Access Compliance Report Public Rights-of-Way (Pedestrian Signals)

Main Street: **ANTONIO_PKWY** Cross Street: **AVENDALE_BLV** Location: **SW**

ADA ID: **SGRK211115171944** Signal Type: **One Push Button-Non APS** Overall Compliance: **No** Severity Scores: **BTN 1: 35** **BTN 2: N/A** **No BTN: N/A**

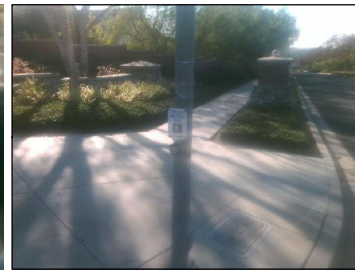
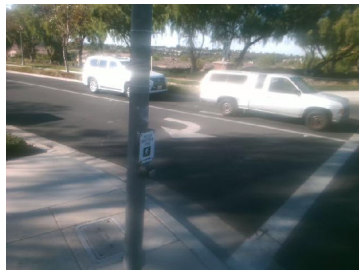
OC Std/PROW: **R404.2, MUTCD 4e.08**

Possible Solutions: Replace Signal Push Button With APS Button. Remove and Replace Clear Space.
